City of Sandy

Parks & Trails Advisory Board Meeting

Meeting Date: Wednesday, June 8, 2022

The Parks Board should discuss the following topics. These questions were submitted by the developer as part of the Vista Loop Subdivision Pre-Application document (Attachment A).

PRELIMINARY EXISTING CONDITIONS PLAN
VISTA LOOP DRIVE SUBDIVISION
SANDY, OREGON

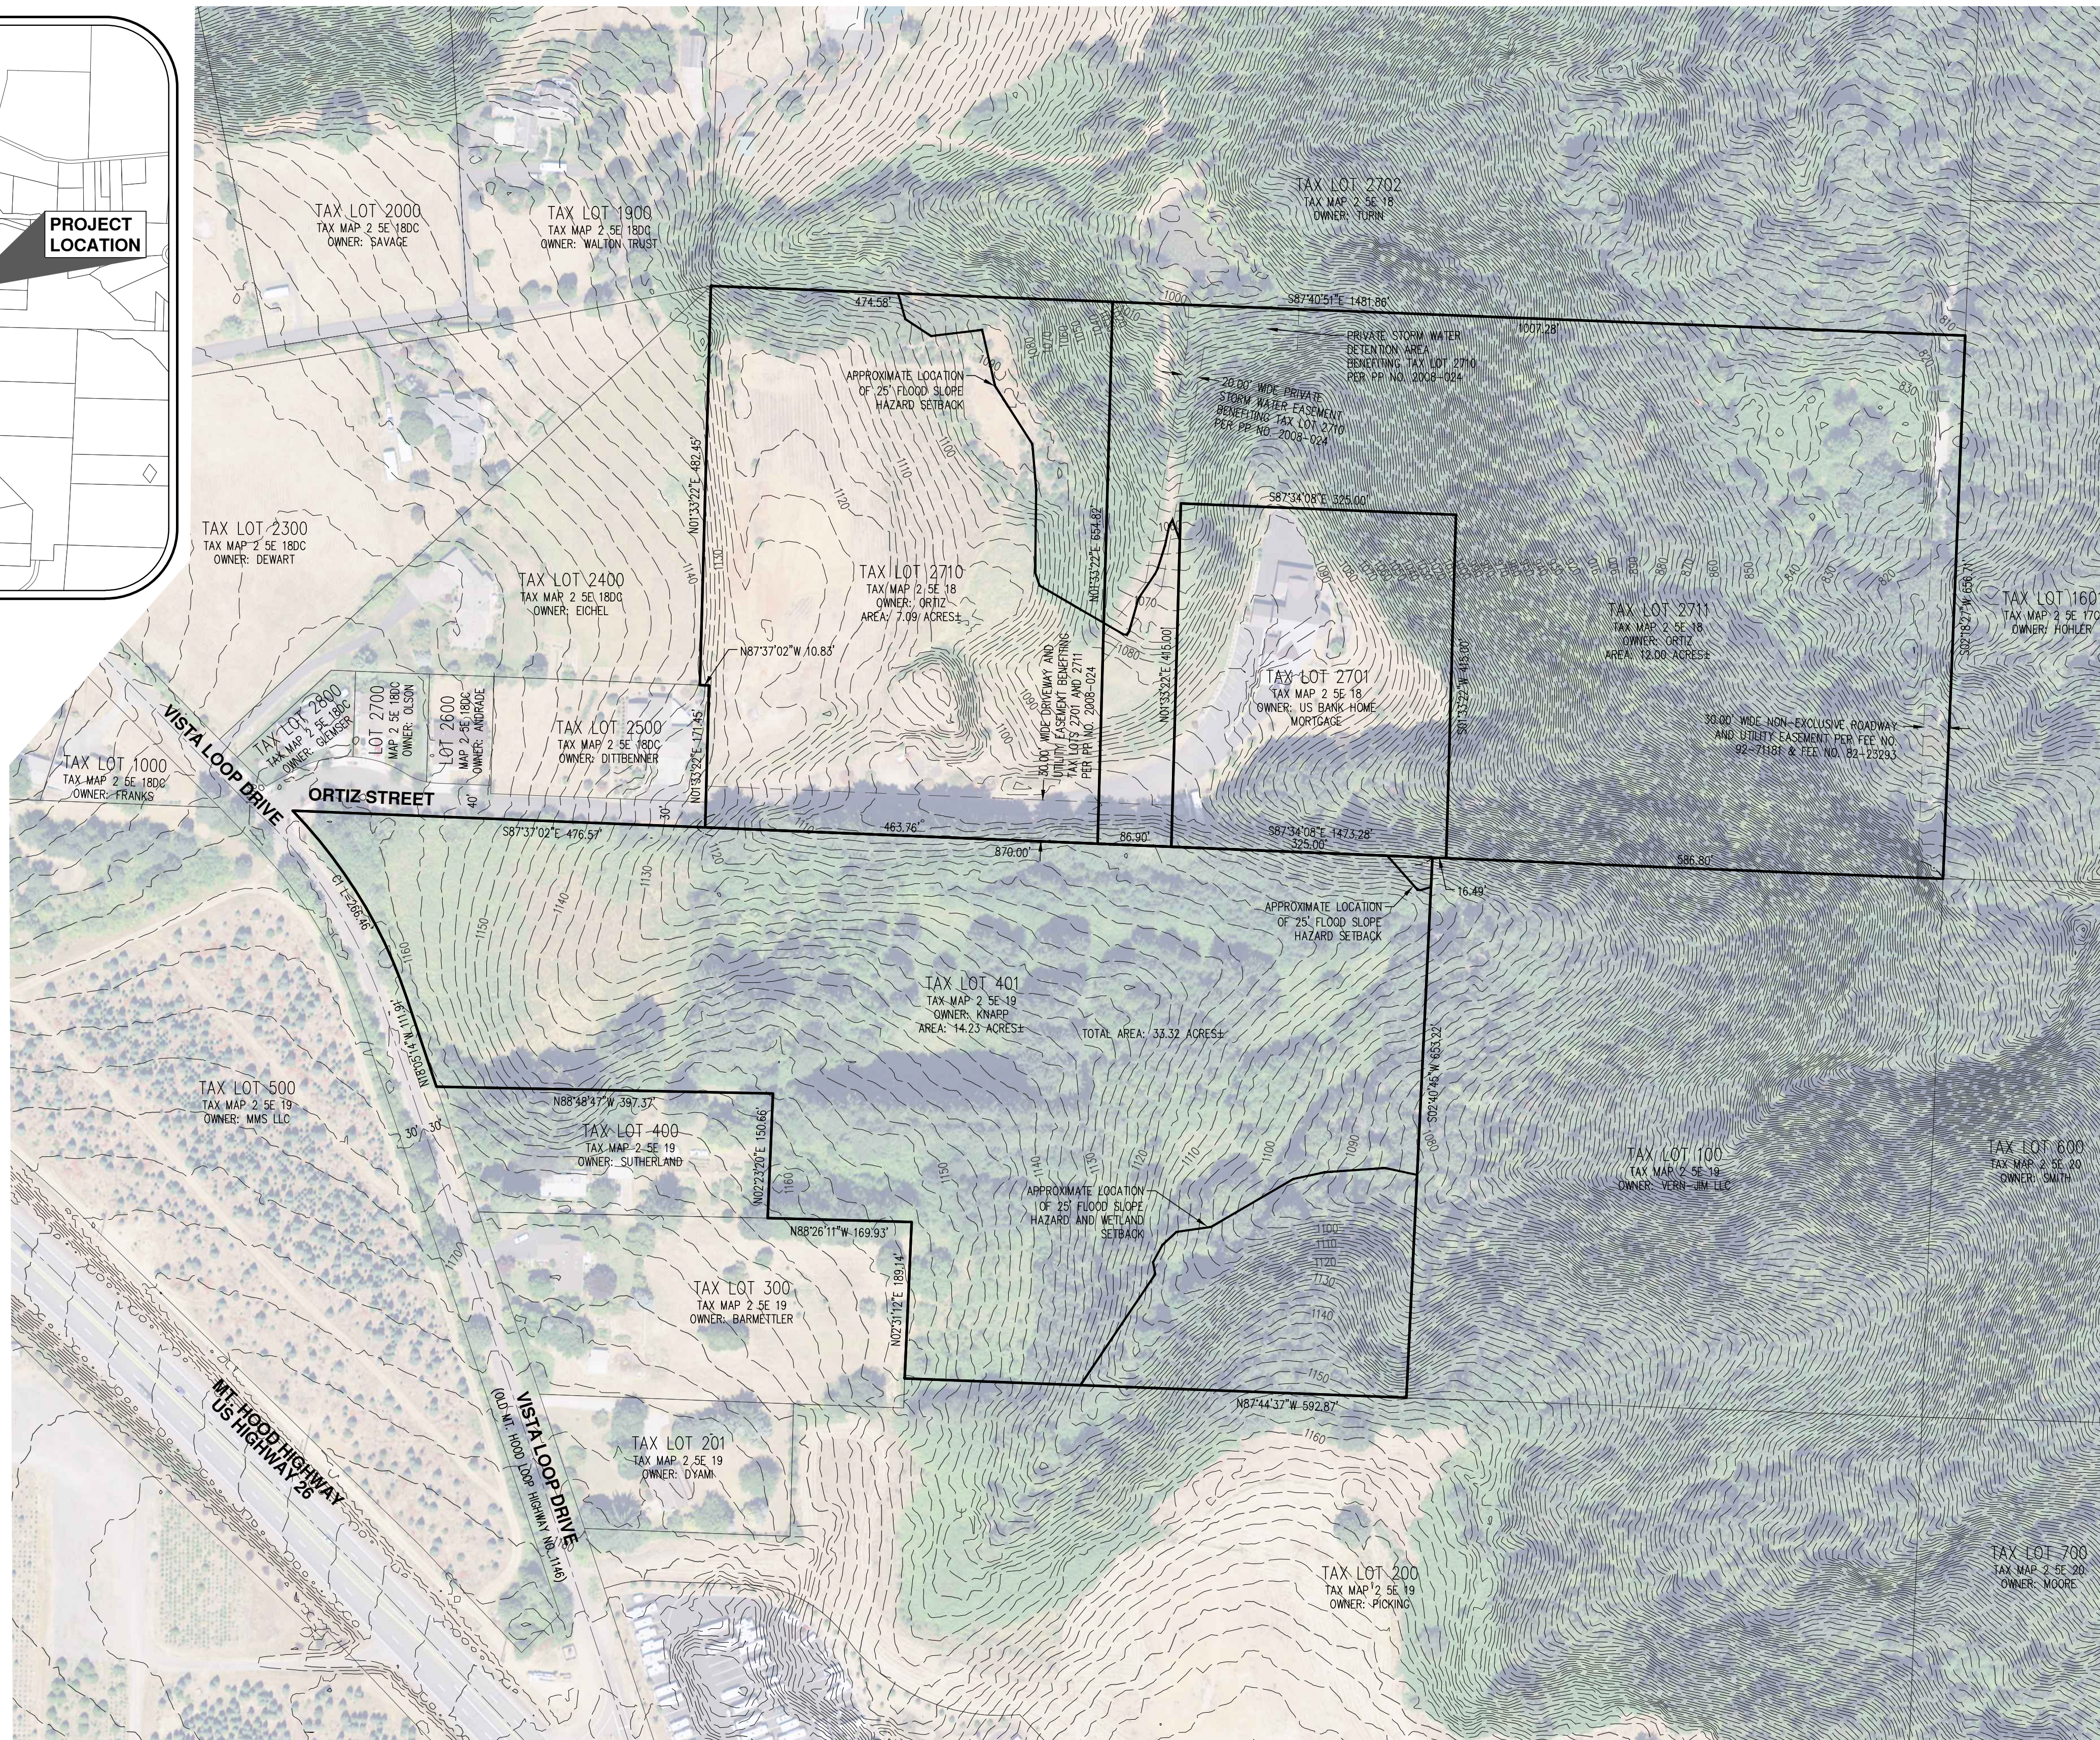
25. Please advise if the street curves on Ortiz Street in front of lots 2 and 3 are acceptable as shown on the Preliminary Site Plan. This design reflects of the property boundary of the adjacent properties to the north of Lots 2 and 3.

Sandy Parks & Trails System Master Plan (2021) - Map 14, Proposed Trail System

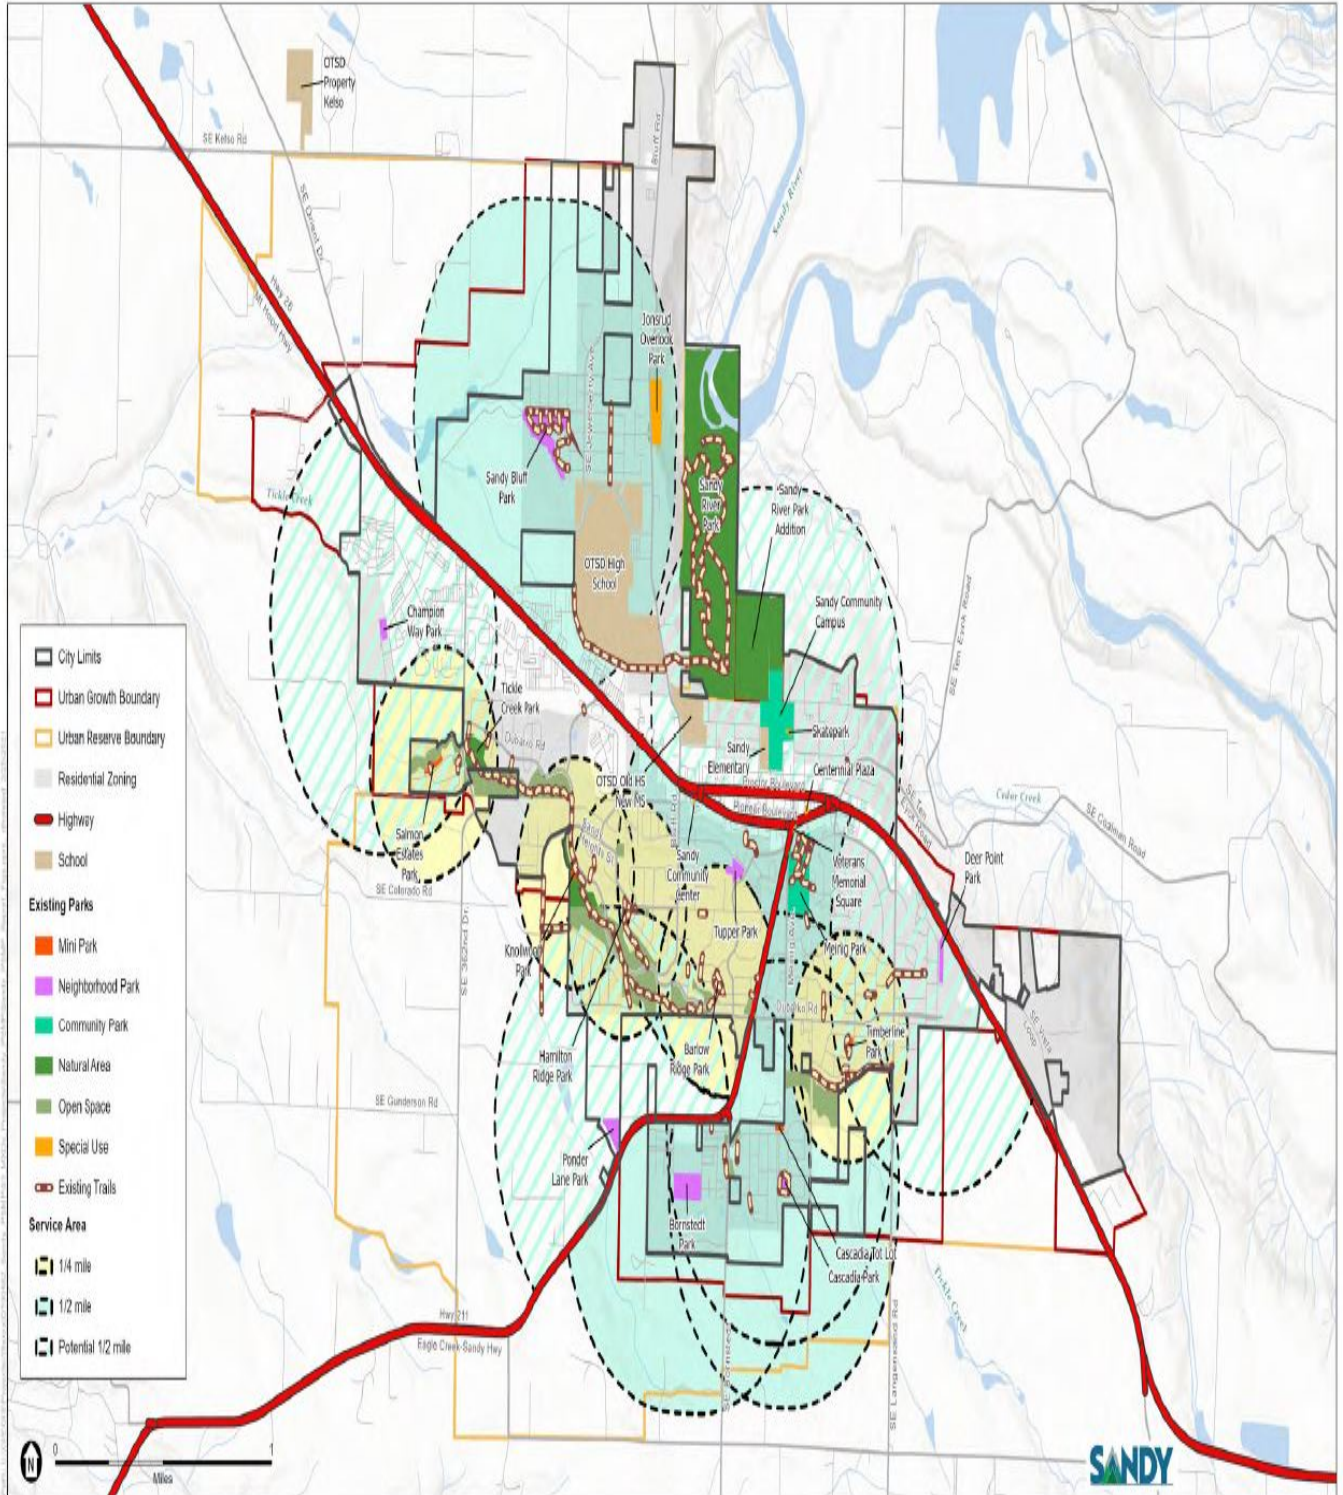
Question (9):

The Proposed Trail System Map in the 2021 Sandy Parks & Trails System Master Plan shows a "proposed future trail" T22 (Vista Loop to Longstreet Lane) routed through the project site. Please discuss if the project is required to accommodate a future trail. If so, please provide a typical trail cross section, the planned trail alignment to the south, and advise if the public sidewalk can serve as portions of the trail.

T22 is a proposed trail in the PTMP. Please see attached map. The Parks Board can recommend this is part of the development. In the proposed updated code chapter 17.86.10 states, "The dedication or provision of parks, open space, trails, and amenities shall comply with the 2022 Parks and Trails Master Plan..."

Map 8
Proposed Park System

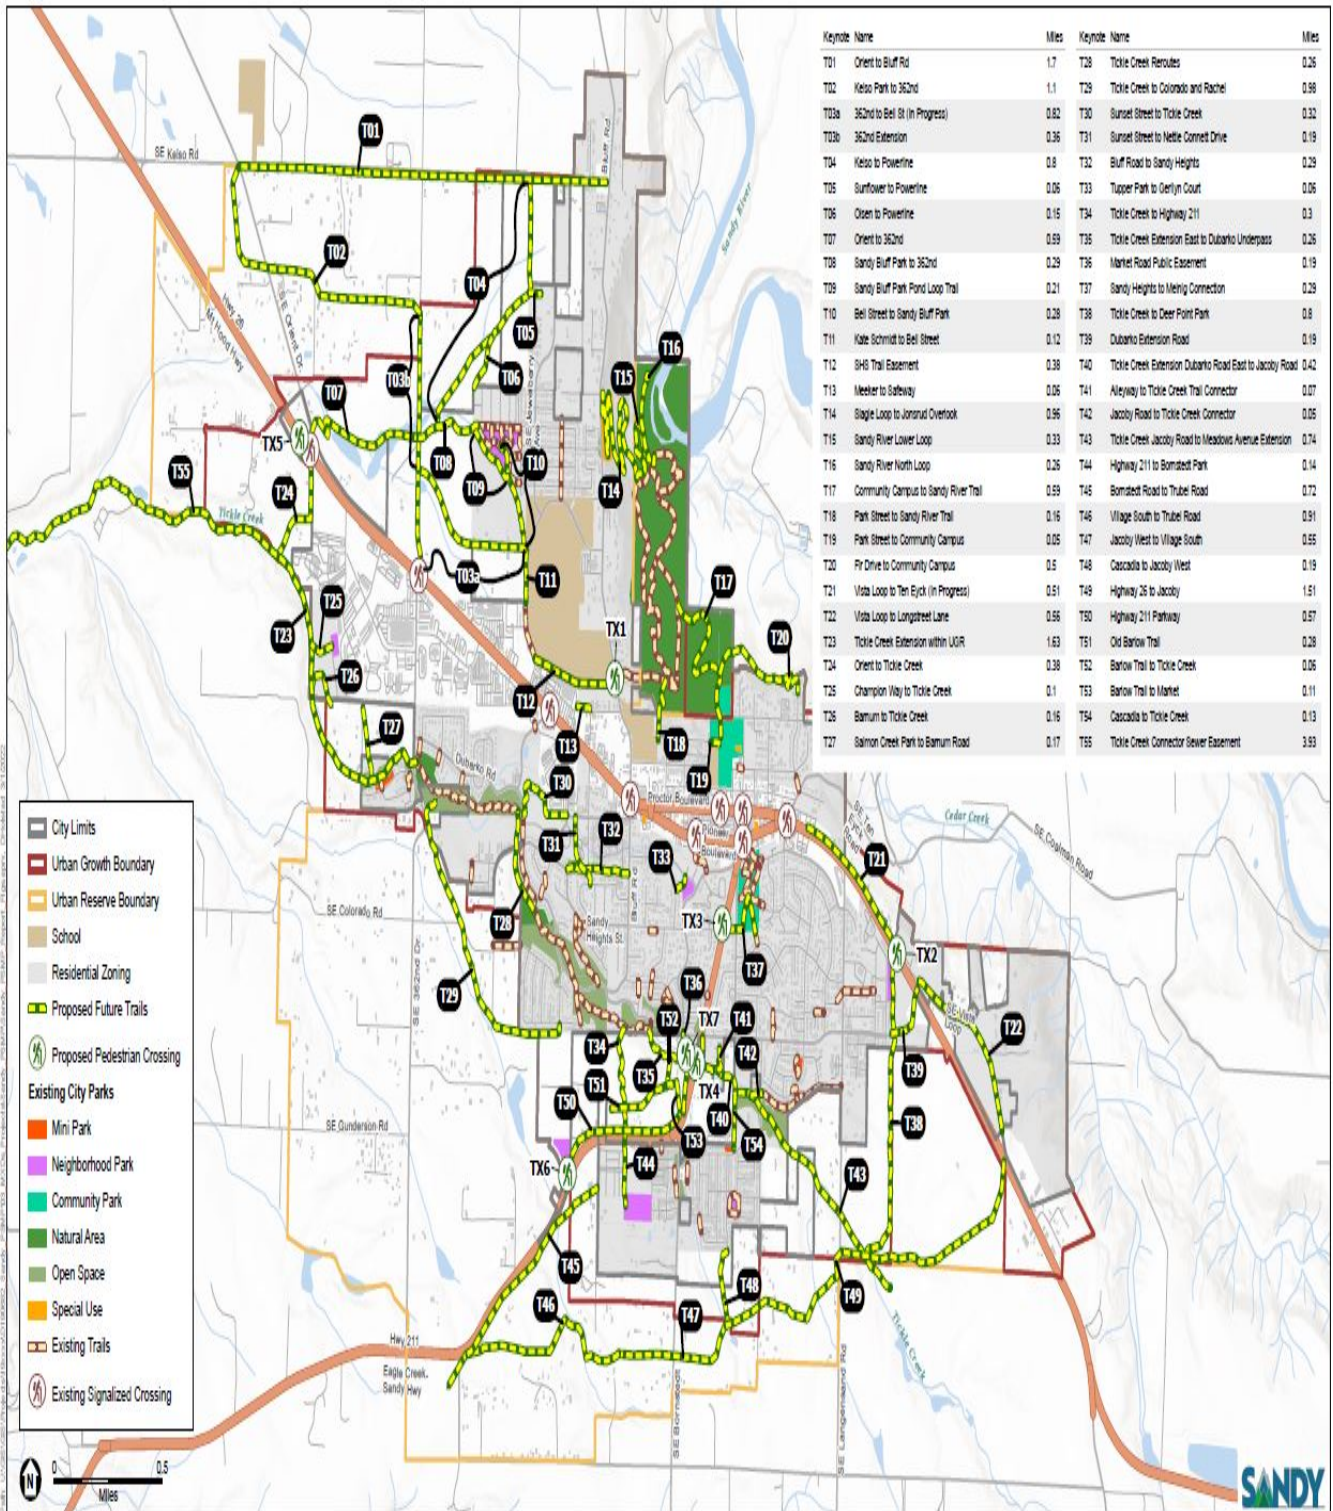
Question (8):

The Comprehensive Plan Map, adopted in 1997, identifies a Neighborhood Park on the project site; however, the Proposed Park System Map in the 2021 Sandy Parks & Trails System Master Plan does not. Please advise if a future neighborhood park will be required by the City on this property.

The 2022 Parks and Trails Master Plan (PTMP) shows a neighborhood park (NP8) as a proposed future park location. See attached 'Proposed Park System' map. Neighborhood parks provide close-to-home recreation opportunities and are located within approximately 5-10 minute walking time from local residences, without crossing major roads and are generally 2-5 acres in size. This project is anticipated to require ± 0.94 acres of parkland, using 0.0043 parkland dedication. However, the multiplier is anticipated to increase to 0.0068 after the June 6, 2022 Council meeting via an emergency ordinance. If the increased multiplier is used the anticipated parkland dedication would be ± 1.49 acres.
